MIAMI BEACH PLANNING DEPARTMENT

Staff Report & Recommendation

SUBJECT: **PB23-0636. 1100 Fifth Street. New Office Building.**

Figure 1: Ground Floor Valet Route

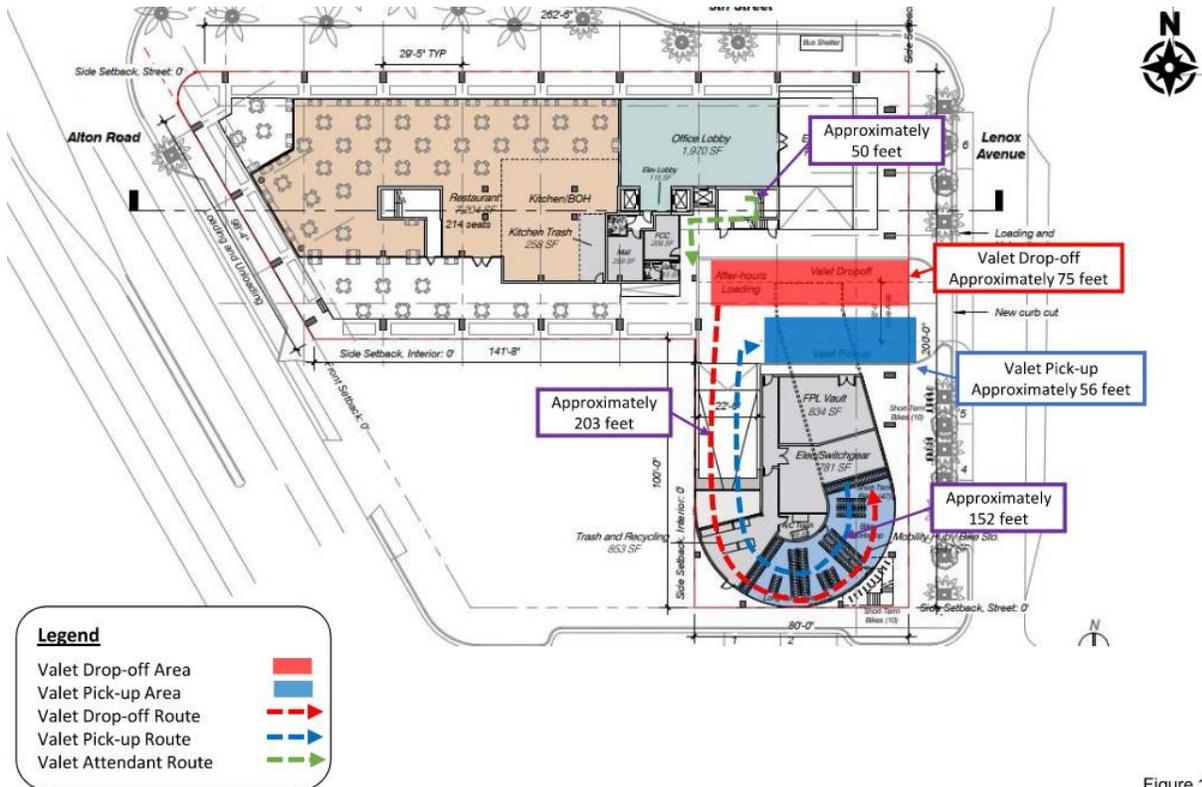
Figures 1 and 2 provide a graphic illustration of the proposed ground level valet routes to and from the on-site parking garage.

The results of the PM peak hour Valet Operations Analysis demonstrate that a minimum of eleven (11) valet attendants, five (5) for the valet drop-off area and six (6) for the valet pick-up area, would be required to ensure future valet queues do not exceed the existing storage available at the valet drop-off/pick-up area during the highest PM peak valet demand scenario.

- c. The applicant shall commit to provide the minimum number of seven (7) valet runners during the AM peak demand period and eleven (11) valet runners during the PM peak demand period. This number should be adjusted as necessary when higher than normal peak demands are encountered
